Docket Number:	23-OPT-02
Project Title:	Darden Clean Energy Project
TN #:	264067
Document Title:	FCFPD revised staff assessment comment
Description:	N/A
Filer:	Joseph Andrew Cosentino
Organization:	Fresno County Fire Protection District
Submitter Role:	Public Agency
Submission Date:	6/5/2025 4:57:09 PM
Docketed Date:	6/5/2025

I am writing to request that item "B" and item "C" under Worker Safety-12 of the Darden Clean Energy Project Updated Staff Assessment released on 5/12/2025 be reconsidered after reviewing the accompanying information. Fresno County Fire Protection District consulted with the County of Fresno Assessors Office to verify IP Darden's statement regarding their portion of property taxes. The information provided by IP Darden was assumed and did not include any confirmed property tax numbers from the County of Fresno.

FUNDING METHODOLOGY FOR BESS AND PV PROJECTS

FIGURE 1

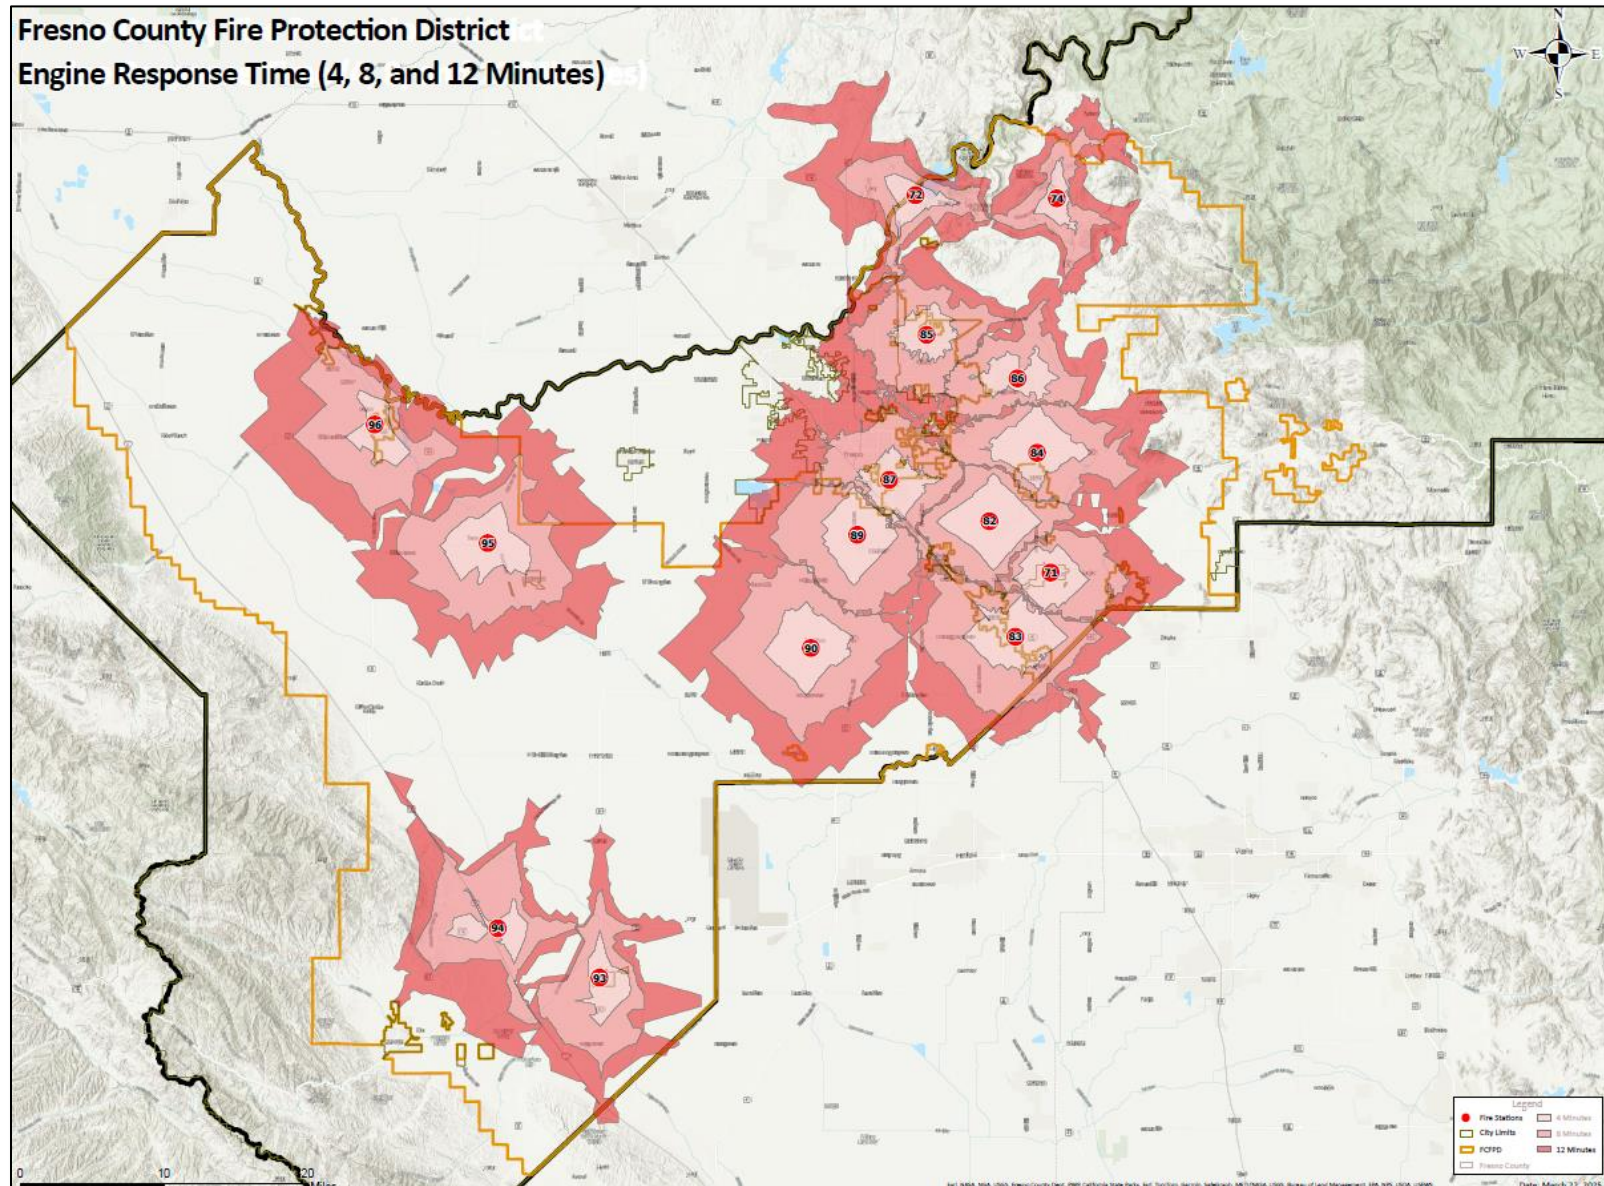
As shown in **Figures 1 and 2**, the District's current fire engine and water tender response does not reach large areas of the western portion of the District where the majority of PV Projects exist or are planned. The future stations, apparatus and necessary personnel will provide adequate fire engine and water tender response times to the PV Projects as illustrated in **Figure 3**.
